## &lt;Addendum #3&gt;

**PROJECT #: EL-0006-C01**

**DESCRIPTION: Elizabeth Academic High School**

| DWG REF. NO.: | P-101A       |

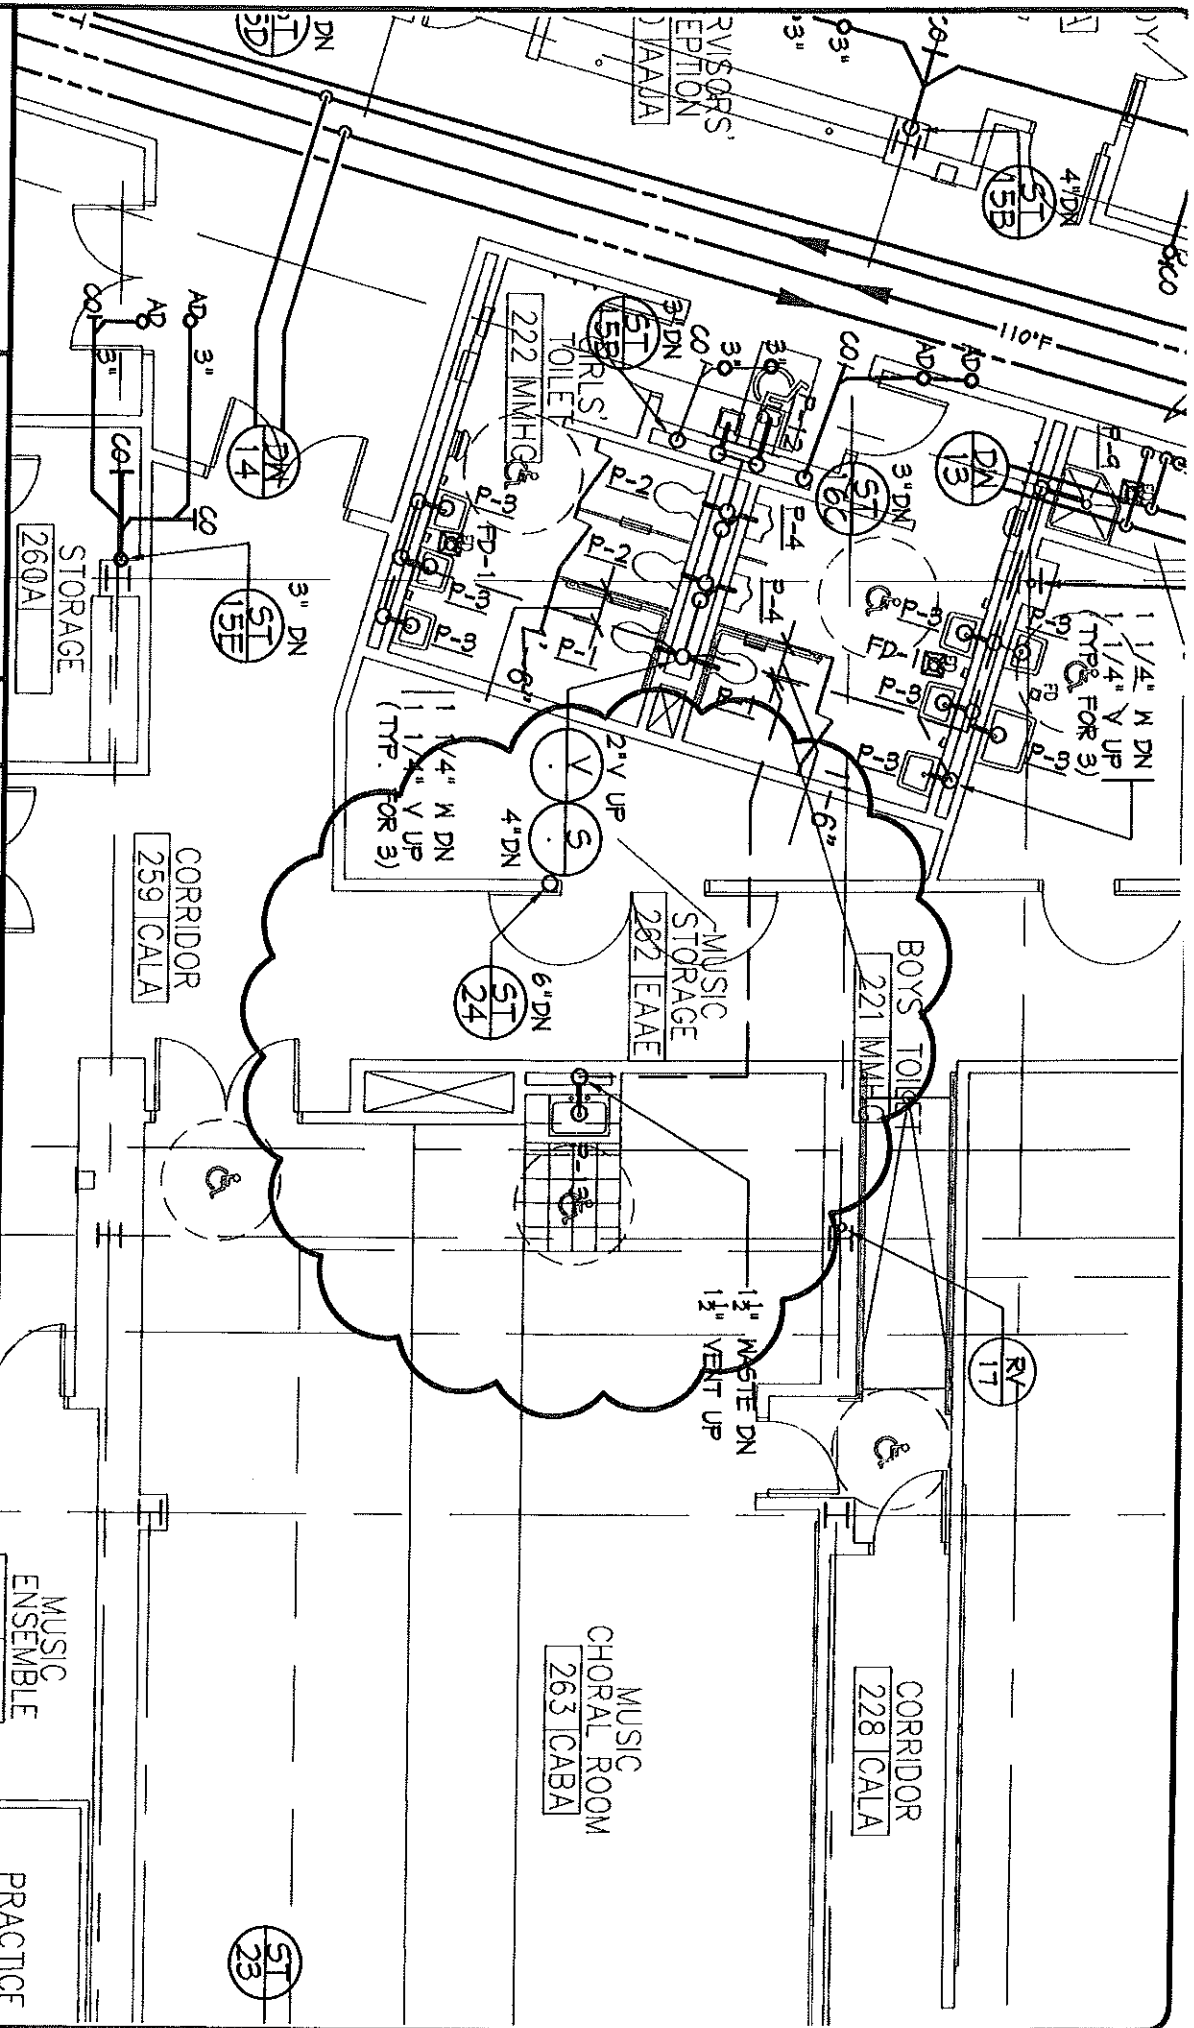
**A.2 Question:** On print P-101A, there is no Leader #25 (underground). On print P-205A (Storm Riser) there is no Leader #25. However on prints P-102A, P-103A and P-104, Leader #25 appears on all three pages. Is there a Leader #25? Please clarify.

**A.3 Question:** Leader #16 does not appear on P-101A (underground) or on the 1<sup>st</sup>, 2<sup>nd</sup>, 3<sup>rd</sup> and Riser prints. However, it is on P-104A (4<sup>th</sup> floor) and P-105A (Roof Plan). Is there a Leader #16 or not? Also Leader #24 only appears on print P-104A. Please clarify.

**Answer:** There is a Leader #25. See clarification sketches (Attachment #1) showing the underground connection and riser diagram.

**Answer:** Both Leaders #16 & #24 are required. See clarification sketches (Attachment #1) showing the path through the building along with the riser diagram.

**A-204**

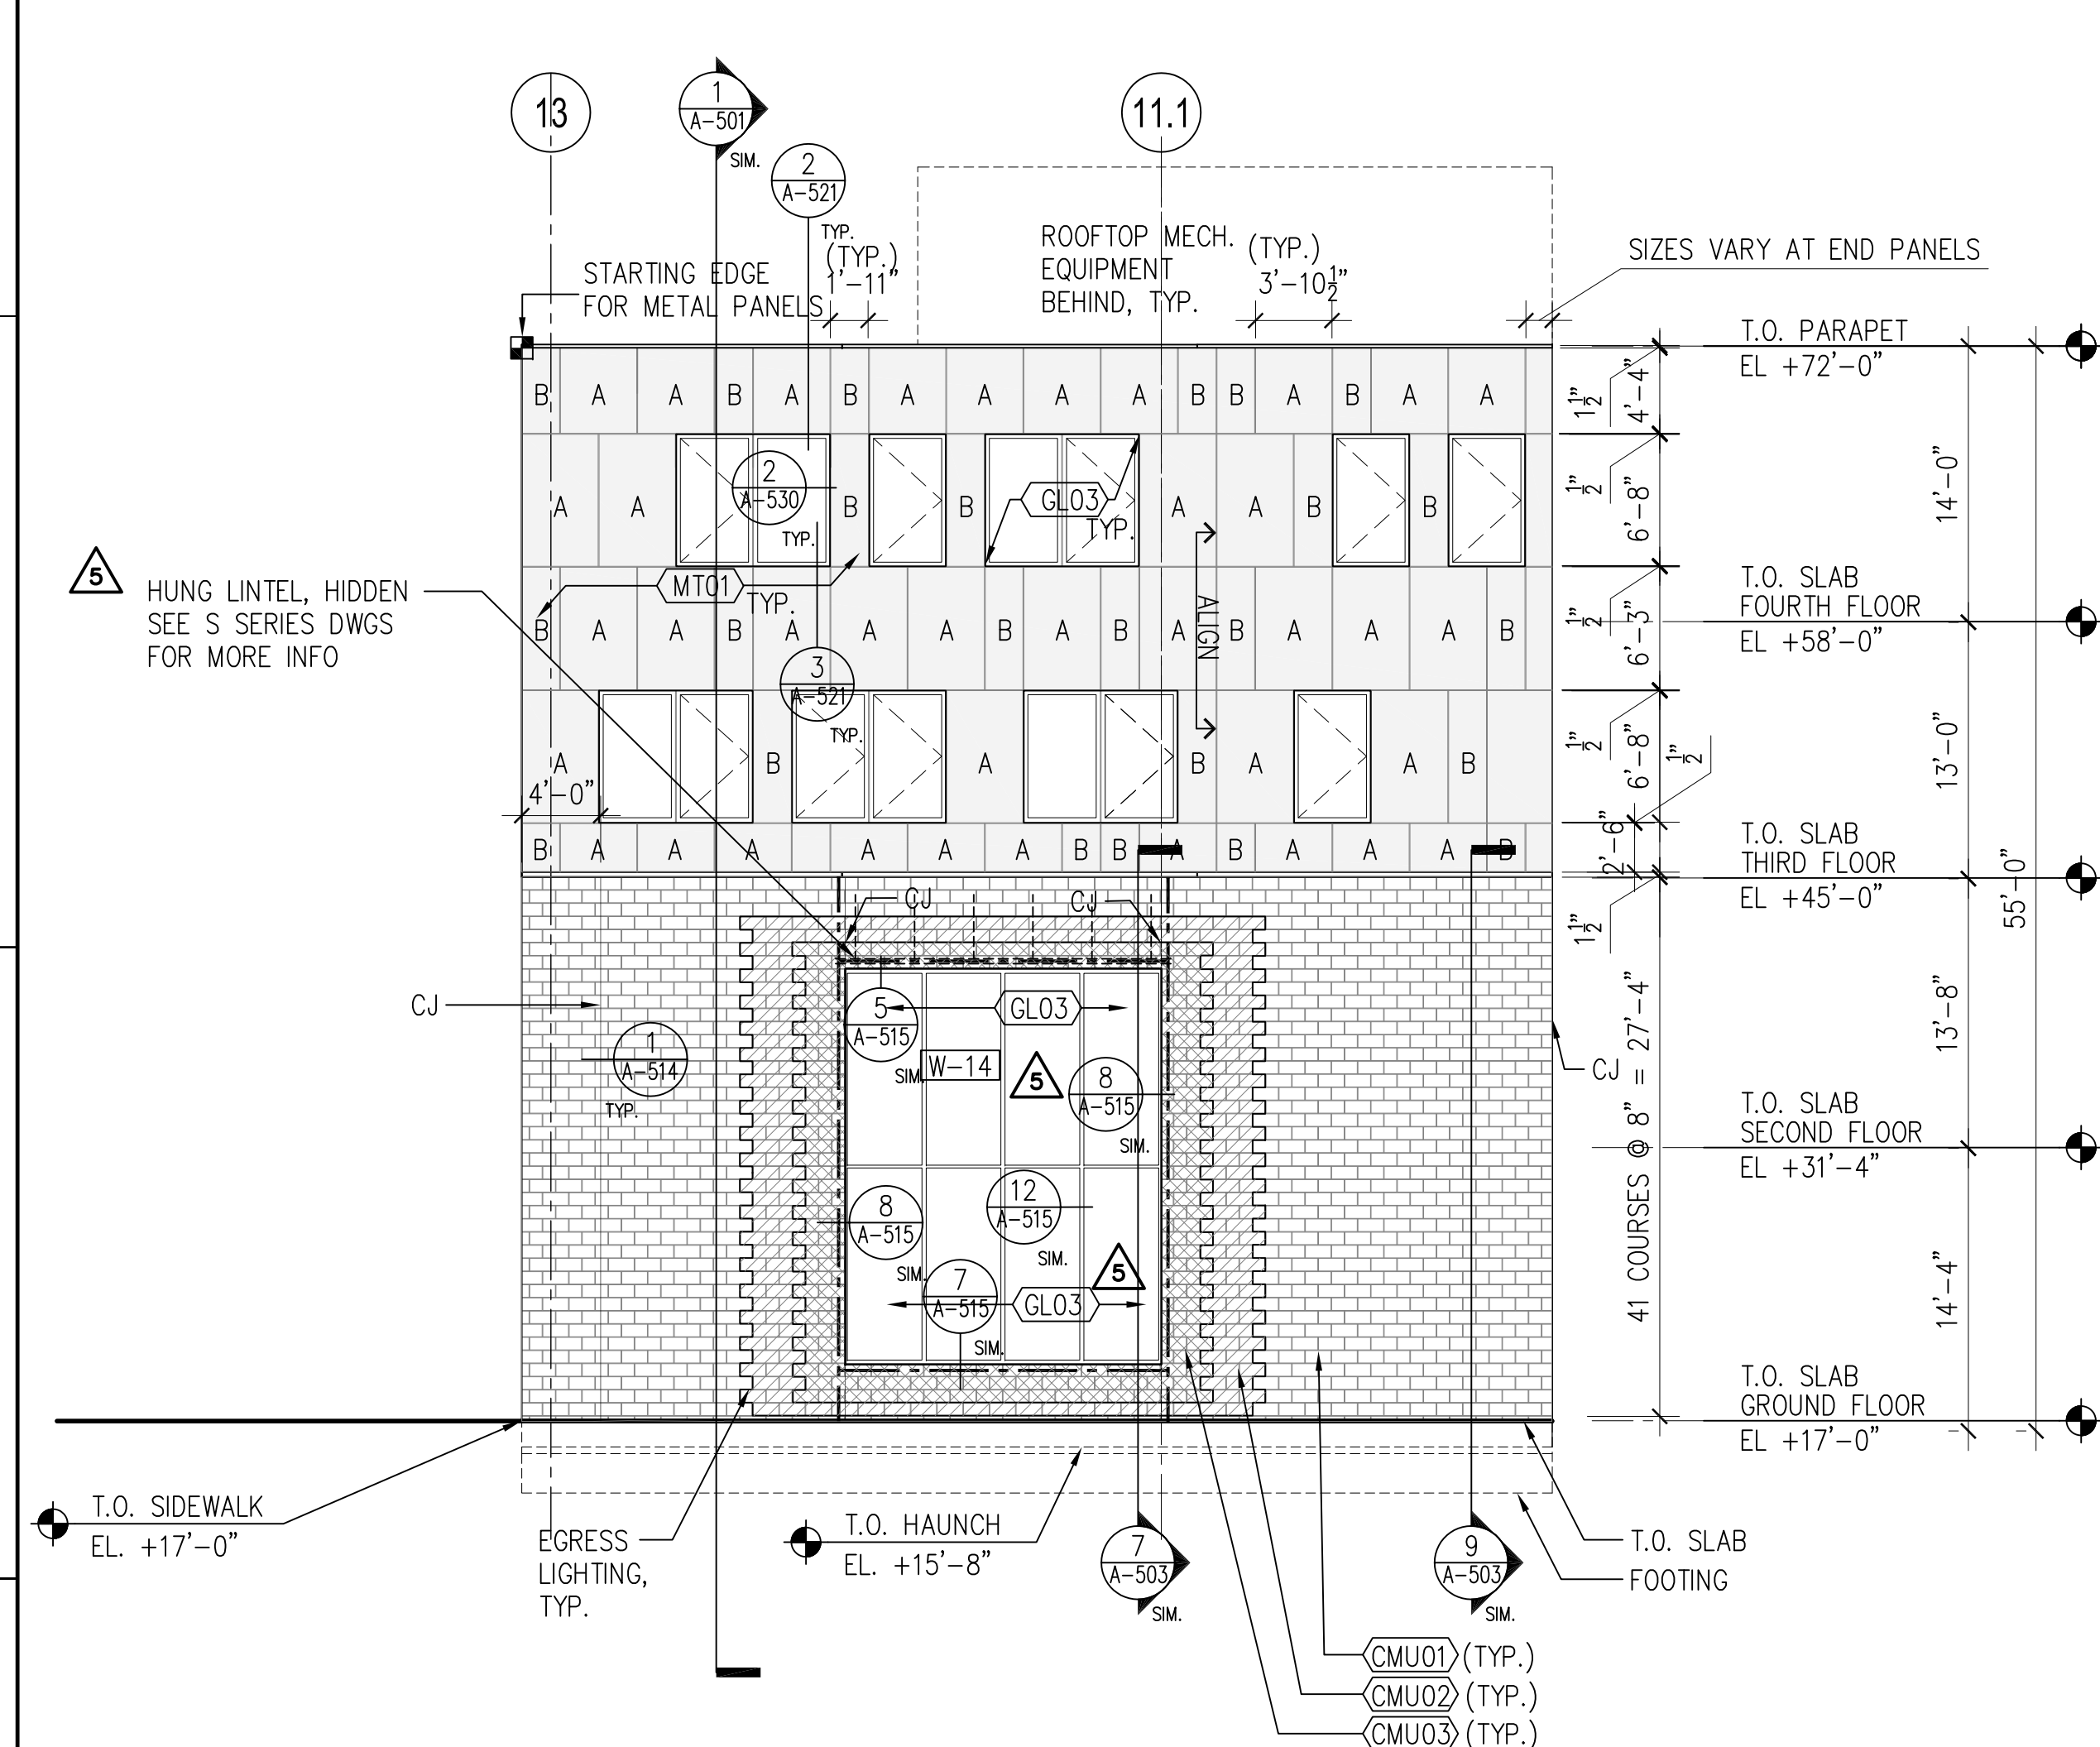
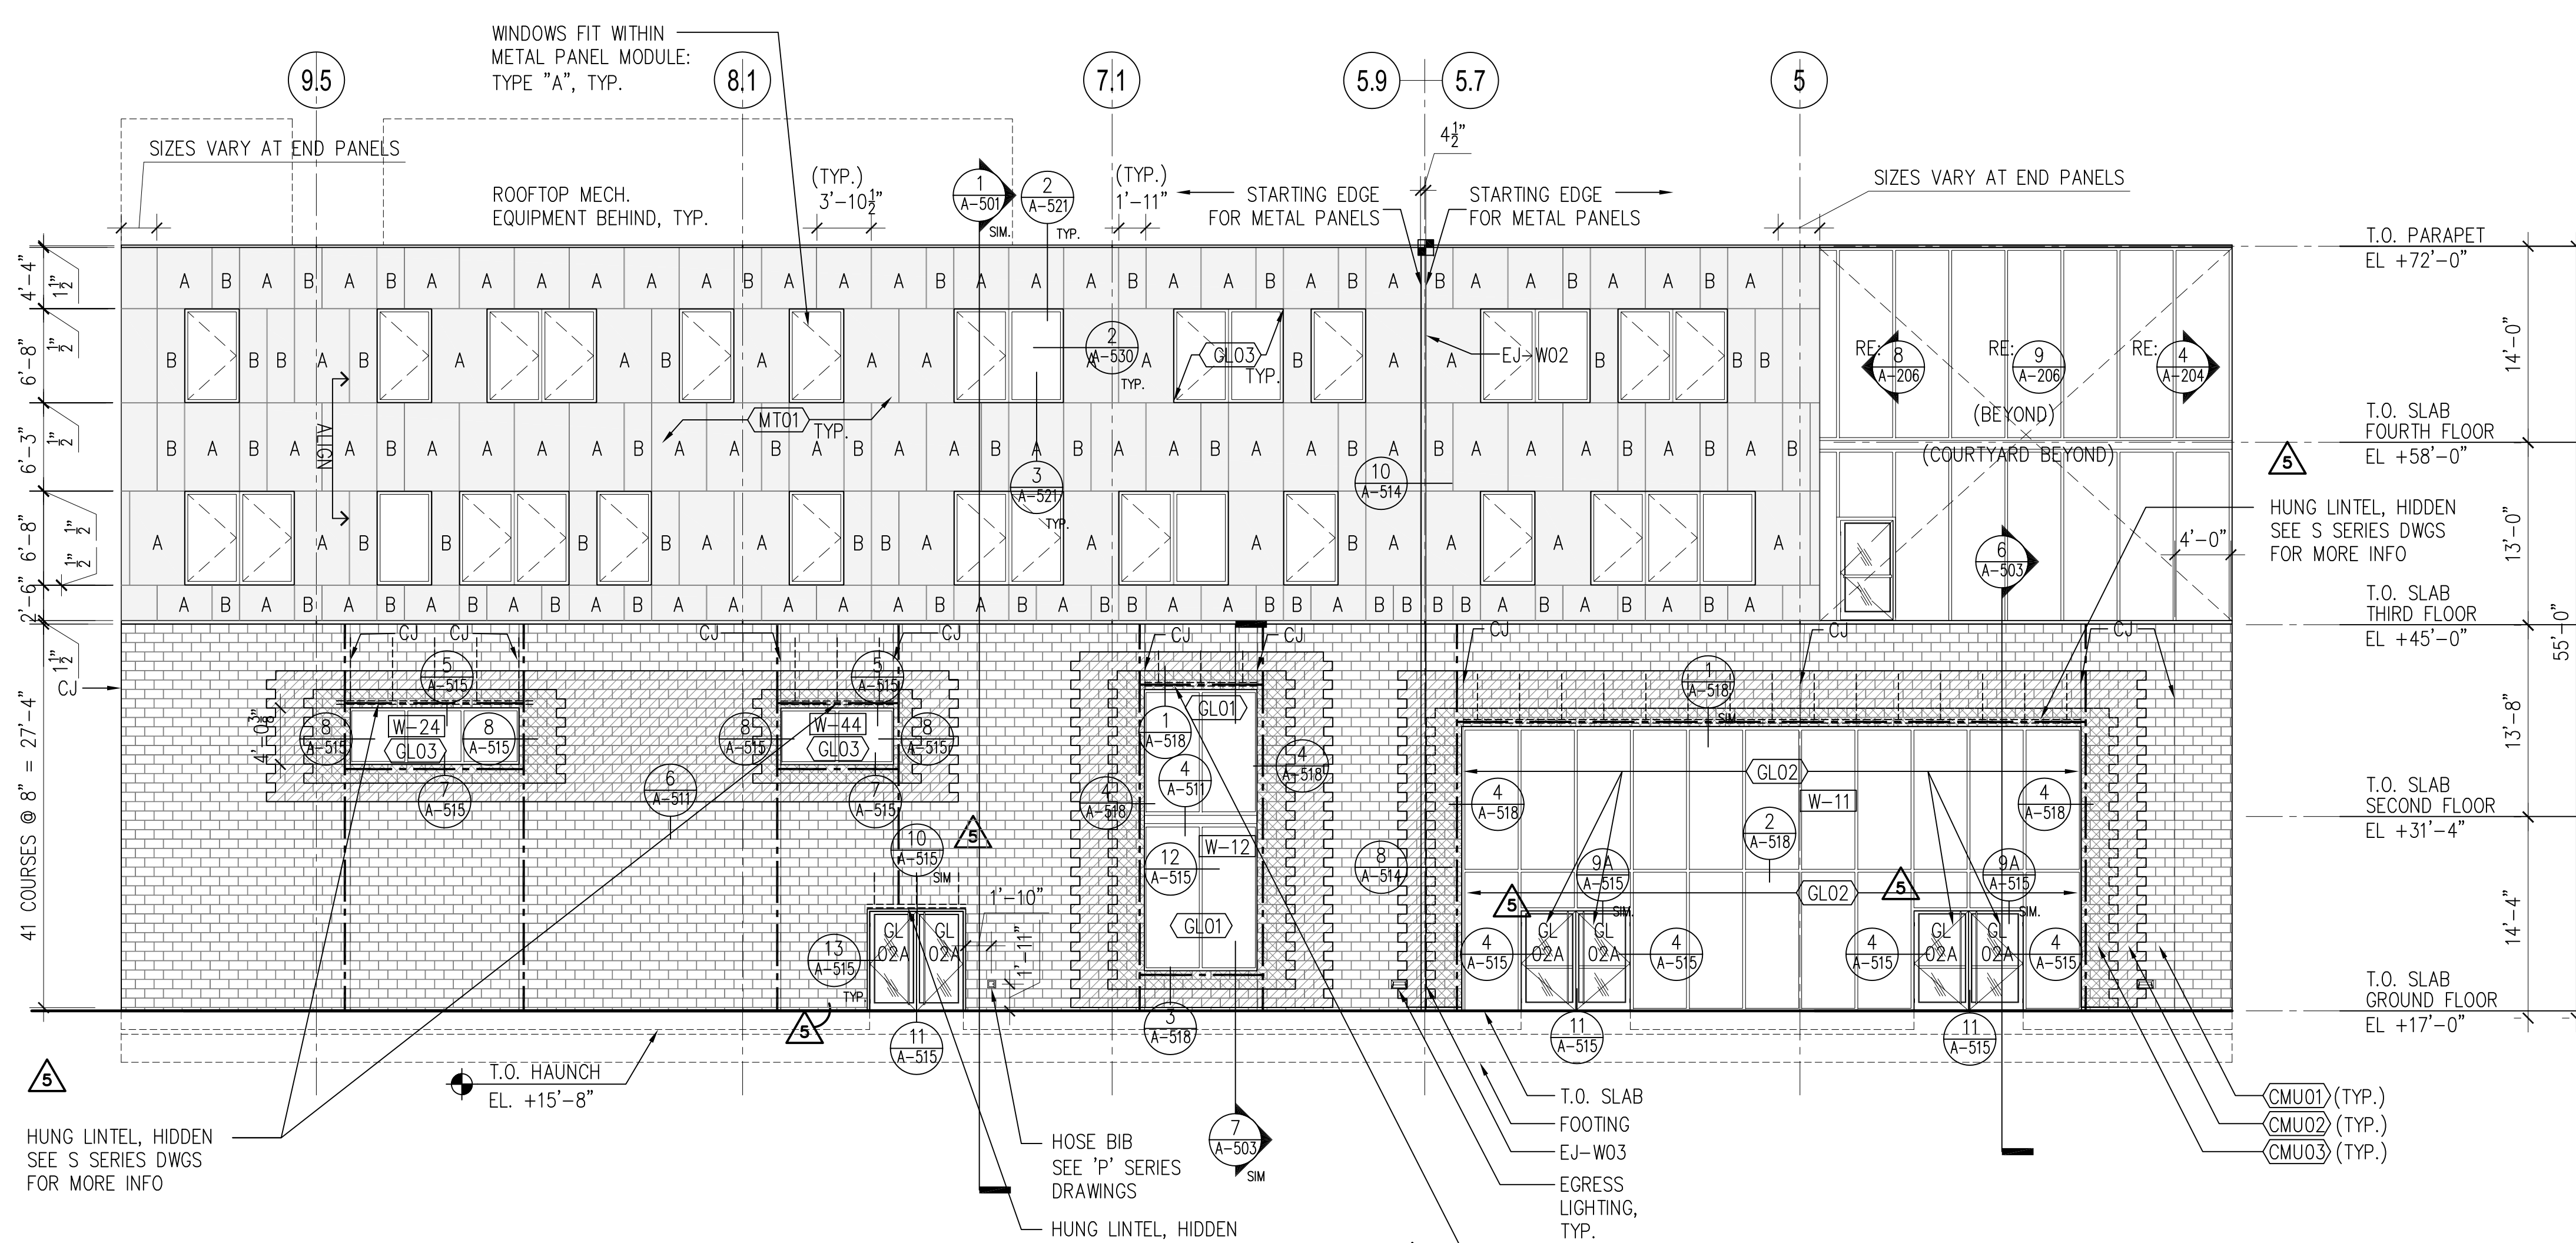
**A.16 Question:** With reference to frame elevation "W-11" (1/A-204), will this frame remain a window as per the exterior window schedule? The detail call outs indicate a combination of stacked window wall and curtain wall. Please advise which system is to be utilized.

**Answer:** The frame shown is a storefront system.
